Re: Kagie Gravel Pit, File No. M-1979-102
Response to Technical Revision (TR-3), Adequacy Review #2

On behalf of West Fish Creek Ranch, LLC, please see the responses, provided below in blue text, to the items identified on the Technical Revision (TR-3), Adequacy Review #2 dated 8/21/2023.

Applicant: West Fish Creek Ranch, LLC
Kagie Gravel Pit
2023 TR
Revised Reclamation Plan Map*

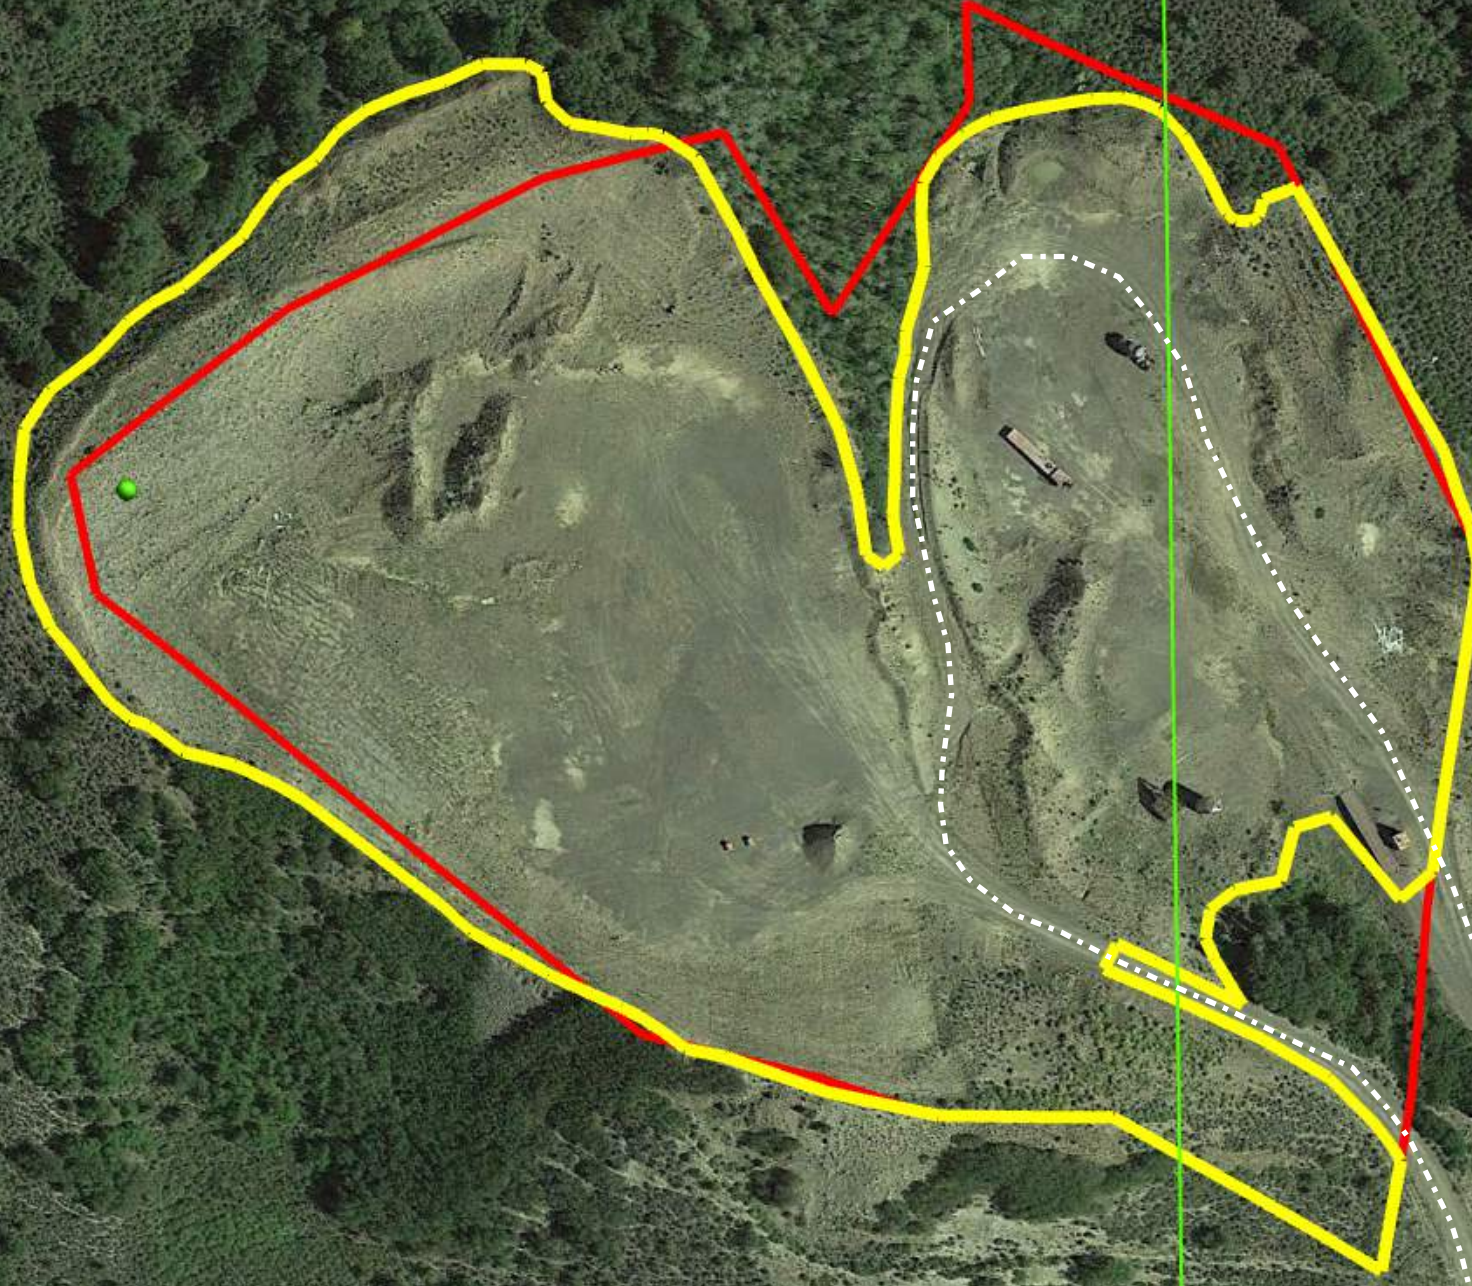
1) Please clarify what the use of the sediment pond is to be in final reclamation. Is it expected that the pond will still function as a sediment pond in final reclamation or will it be left for another use?

Response: Yes, the pond will remain as a vegetated sediment trap for stormwater management after final reclamation. The extraction site will be graded to direct stormwater runoff from the upper bench towards the sediment pond/trap.
